Re: Los Cedros / Harvard Tract

POADP # 715

The City Staff Development Review Committee has reviewed Los Cedros/ Harvard Tract Subdivision Preliminary Overall Area Development Plan. Please note that your plan was not accepted, based on the following:

LOS CEDROS/HARVARD TRACT  
PRELIMINARY OVERALL AREA DEVELOPMENT PLAN

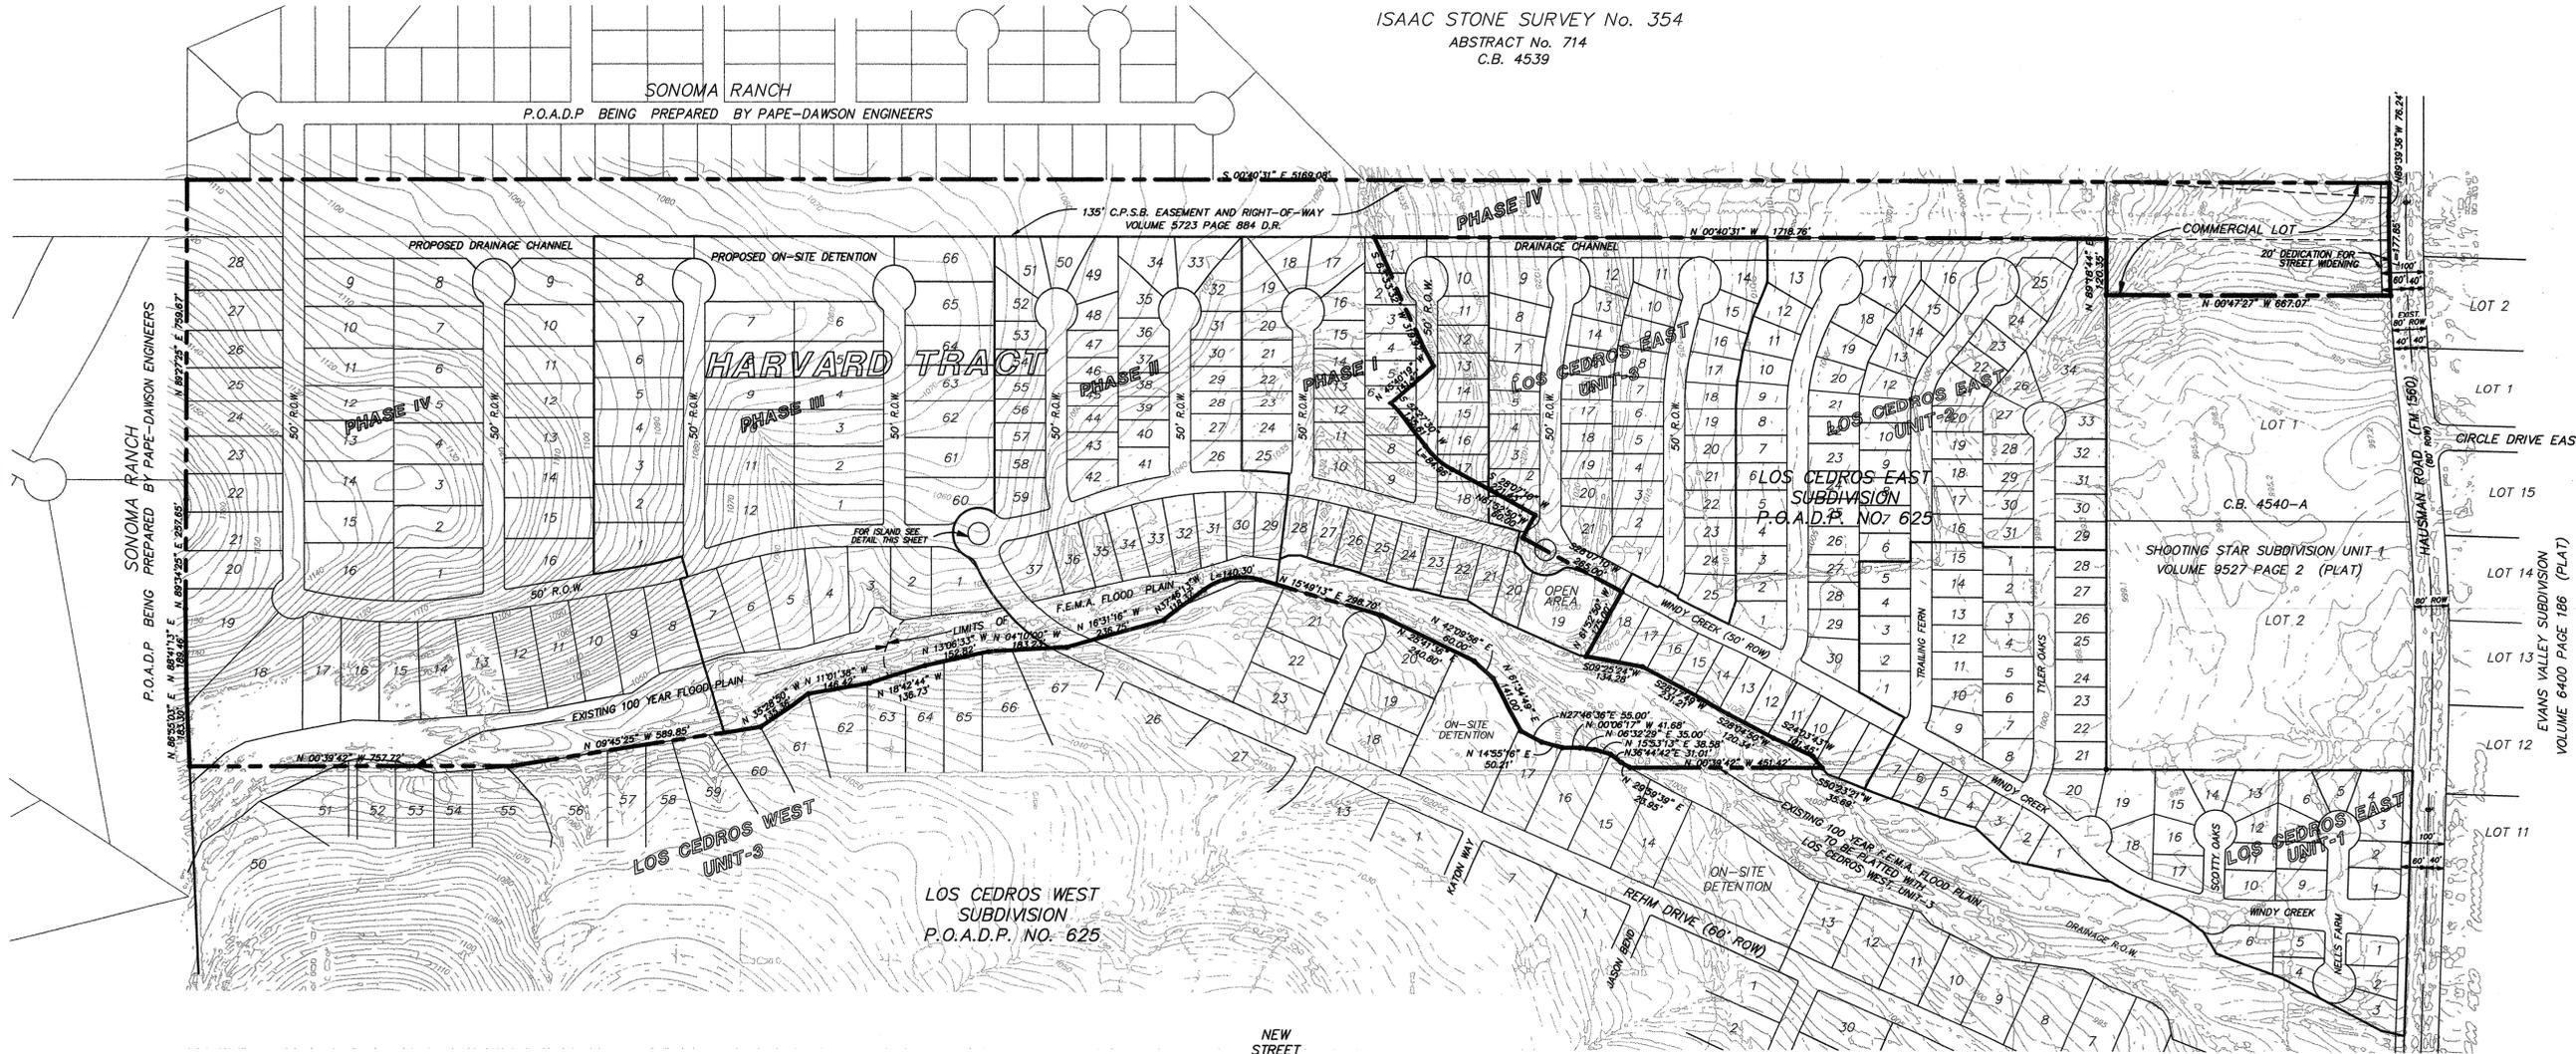
**1.) Sec. 35-2075 Information Required**

- (a) Annotate perimeter property lines.
- (b) Location Map is missing.
- (c) Your project does not indicate phase development.
- (d) Digital file is missing.
- (e) Coordinate with Sonoma Ranch (Pape-Dawson Eng./ Mr. Al Chua) for connectivity to the north.
- (f) Contour lines are not labeled.
- (g) Ownership of adjacent properties is missing.
- (h) Hausman Road right-of-way width is not annotated and the F.M. designation is missing.
- (i) Tx-Dot is requiring 20' feet of dedication along F.M. 1560 (Hausman Rd.)

(k) A revised T.I.A. will be required.

REVISIONS  
05/08/01 REVISED PER CSA COMMENTS.  
06/26/01 REVISED PER CSA COMMENTS.

PRELIMINARY DETAIL OF ISLAND  
AT REHM DRIVE & WINDY CREEK  
SCALE: 1" = 50'

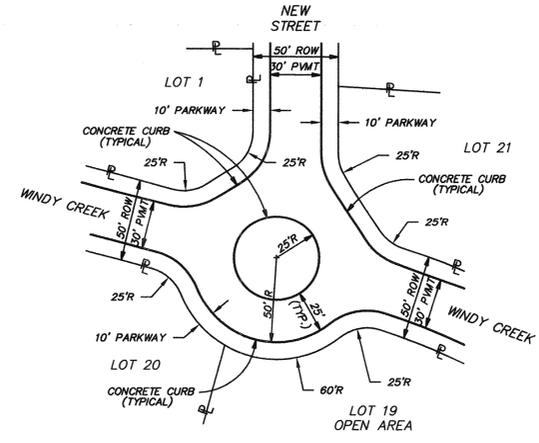
(j) Public Works is requiring a detail of the Island at the intersection of Rehm Dr. and Windy Creek.
